PRODUCT CHANGE NOTIFICATION

Date: October 14th, 2020
PCN: PCN LEDIL 169

Subject: PCN 169 - Change of adhesive tape material

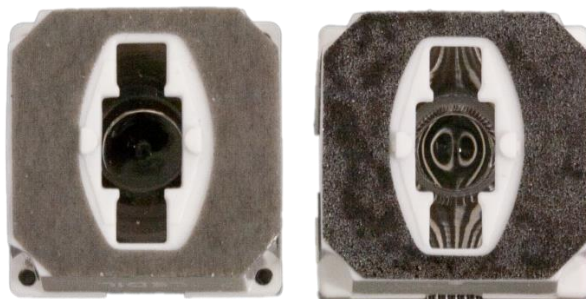
Changes: The 0.4 mm thick polyurethane foam tapes will be changed to acrylic foam tape for the following products listed in this PCN.

NEW TAPE

OLD TAPE
